AMD-K6[®]

Processor Revision Guide

Model 7

Publication # 21846 Rev: H Amendment/ 0 Issue Date: June 1999
--

Figure 1. AMD-K6® Processor Assertion of HLDA Due to Simultaneous $\overline{\text{BOFF}}$ /HOLD Assertion

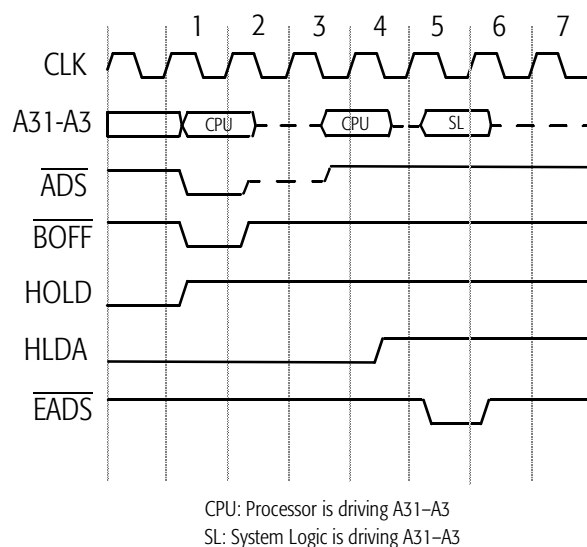
Normal Specified Operation. If $\overline{\text{BOFF}}$ and HOLD are sampled asserted on the same clock edge that negates $\overline{\text{ADS}}$, the processor asserts HLDA one clock edge after HOLD is sampled asserted.

Non-conformance. If $\overline{\text{BOFF}}$ and HOLD are sampled asserted on the same clock edge that negates $\overline{\text{ADS}}$, the processor asserts HLDA two clock edges after HOLD is sampled asserted.

Potential Effect on System. There are three potential effects of this erratum to consider:

- If the system logic asserts $\overline{\text{BOFF}}$ for a duration of one clock, anticipates the assertion of HLDA in clock 3 (see Figure 1)—which is the normal specified operation—and drives the address bus and $\overline{\text{EADS}}$ for an inquire cycle in clock 3, then the processor will not sample $\overline{\text{EADS}}$ asserted. In addition, address bus contention will occur in clock 3.

- If the system logic asserts $\overline{\text{BOFF}}$ for a duration of two clocks, anticipates the assertion of HLDA in clock 3, and drives the address bus and $\overline{\text{EADS}}$ for an inquire cycle in clock 3, then the processor will not sample $\overline{\text{EADS}}$ asserted. (No address bus contention occurs in this case.)

- If the system logic asserts $\overline{\text{BOFF}}$ for a duration of one clock, anticipates the assertion of HLDA in clock 3, and drives the address bus and $\overline{\text{EADS}}$ for an inquire cycle in clock 4, then address bus contention may occur in clock 4. (The processor will sample $\overline{\text{EADS}}$ asserted in this case.)

If the processor does not sample $\overline{\text{EADS}}$ asserted during an inquire cycle, cache/memory incoherency will occur. Address bus contention can affect the reliability of the processor and the system logic.

Suggested Workaround. The system logic must sample the assertion of HLDA before asserting $\overline{\text{EADS}}$ and driving the address bus for an inquire cycle—as shown in clock 5 of Figure 1.

Resolution Status. AMD has determined that all Socket7 and Super7™ chipsets operate as described in the aforementioned suggested workaround. Therefore, AMD has decided to defer the resolution of this erratum until deemed necessary.
